Construction Division
Additions & Alteration Charges Approval Form

Company Name:	MRMLLP	Site	Gulmohar Residency
Name of the customer	Mr. Ramakanta.		
Villa/ Flat No.	C-502.

Quality Control Check Report. Stage: After Finishing Stage III (Apartments)

Details of Additions & Alterations

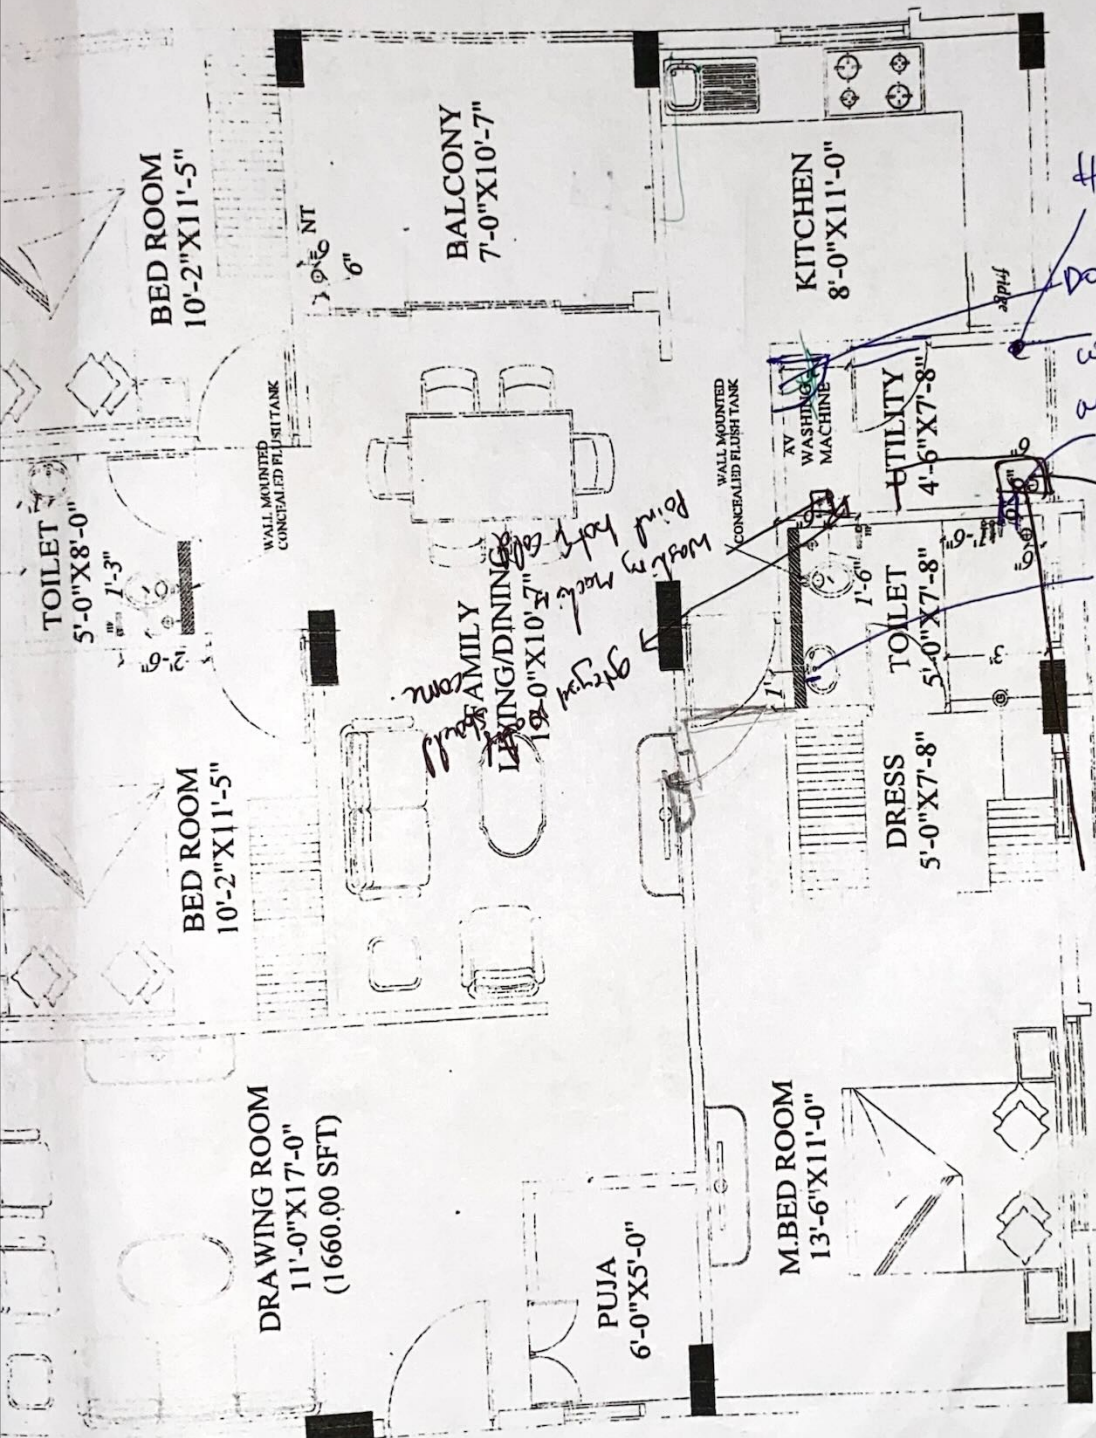
Changes in electrical points: (mark on plan)

Changes in kitchen platform: (mark on plan)

- Hot & cold water taps to be provided for both toilets sinks
- Wall of M.B. to be removed upto column & ~~to door~~ to be change
- Wall near French door to be levelled upto column ~~thick~~ thickness - both sides
- M.T. door opening to be change & showed in plan.

PLUMBING PLAN-1660 Sq (B2-TYPE)

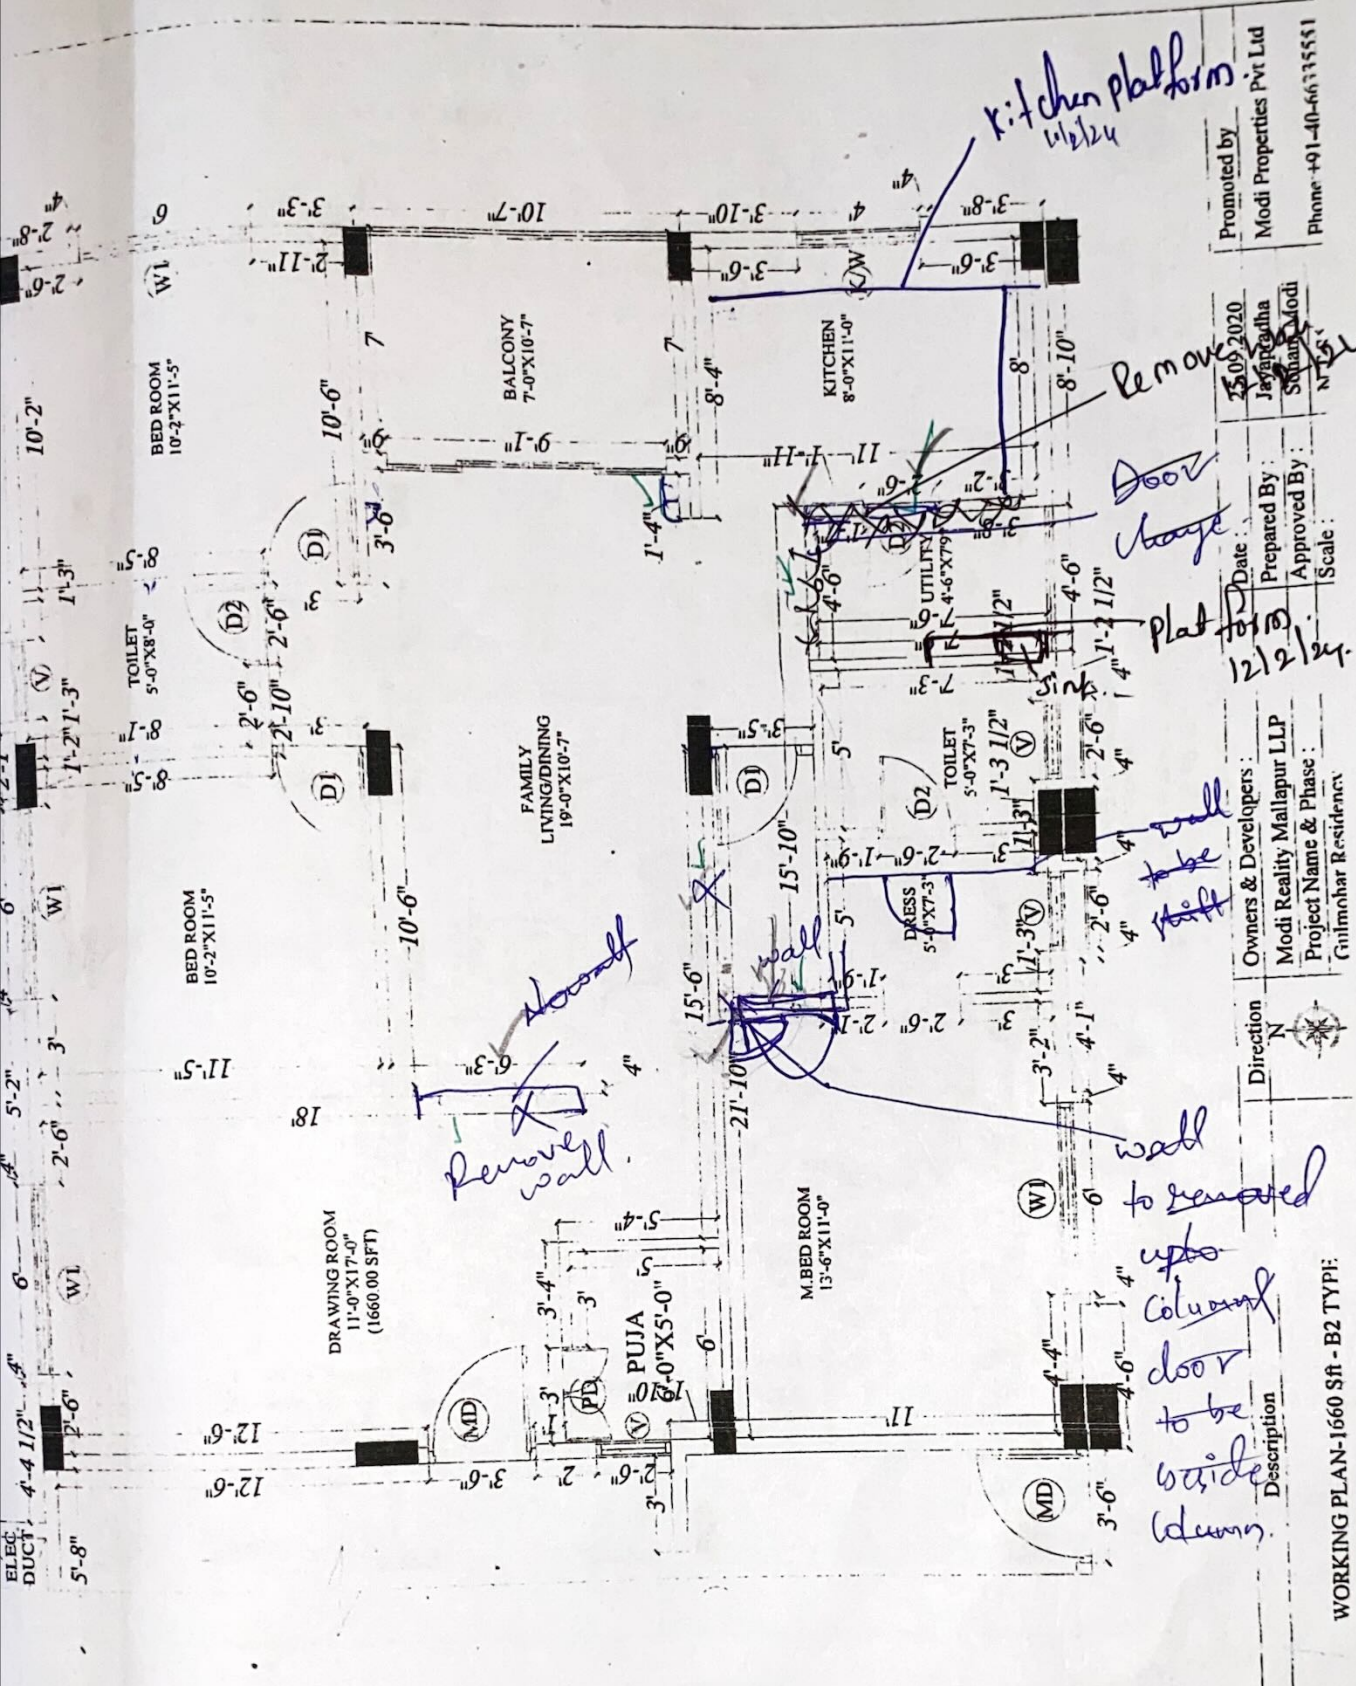
Handwritten notes:
 Point hot water supply
 Wash. machine
 10' x 10' 7" area
 10' x 10' 7" area

Handwritten notes:
 Hot Cold water
 Door
 washing machine

Handwritten notes:
 Manisha q
 Box water connection.

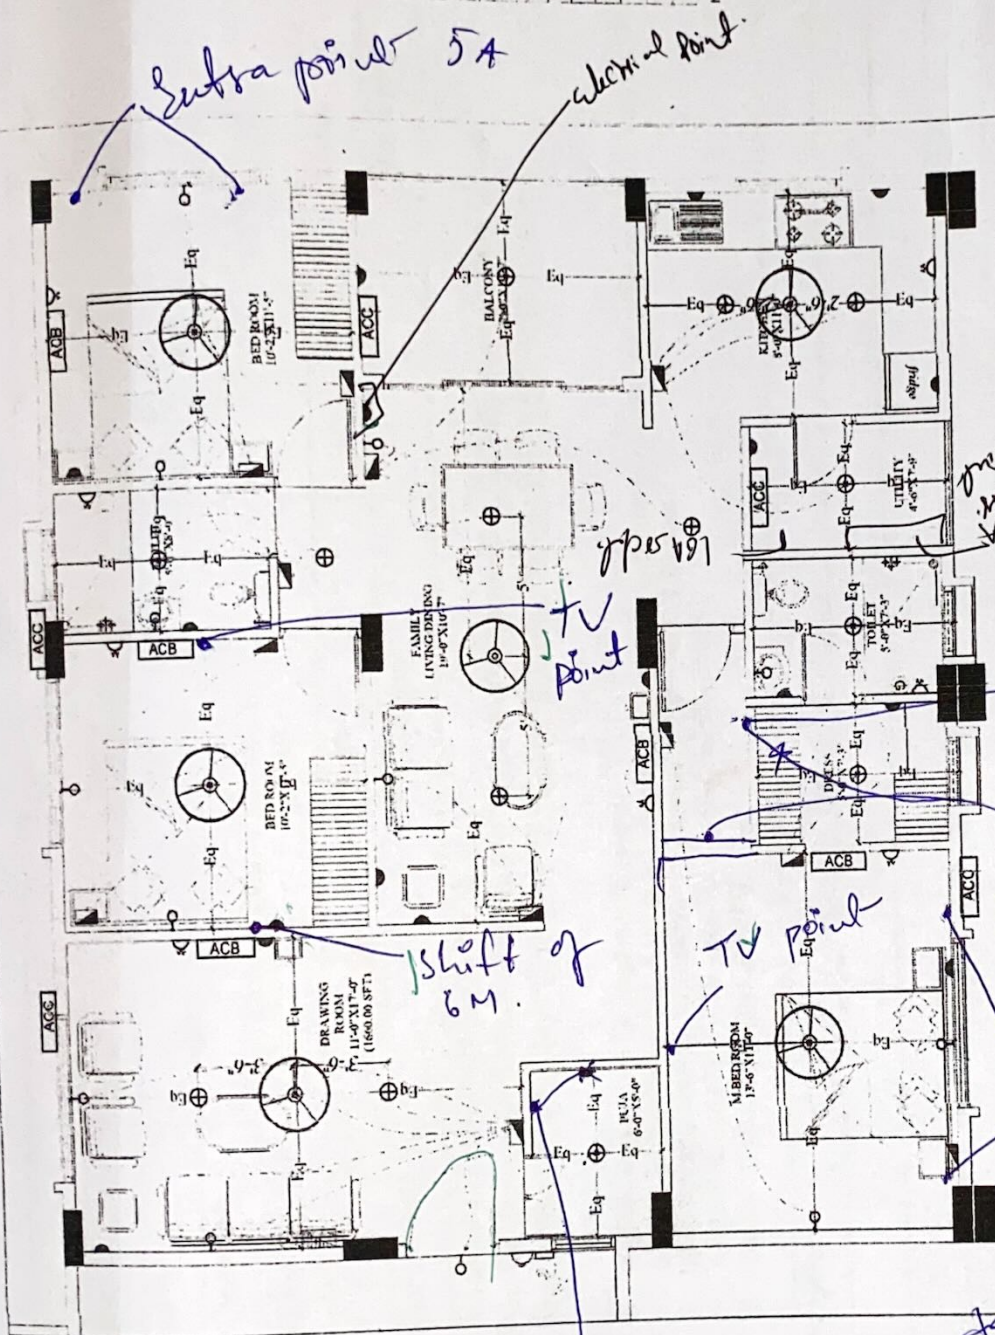
change of 6M

shift of 6M
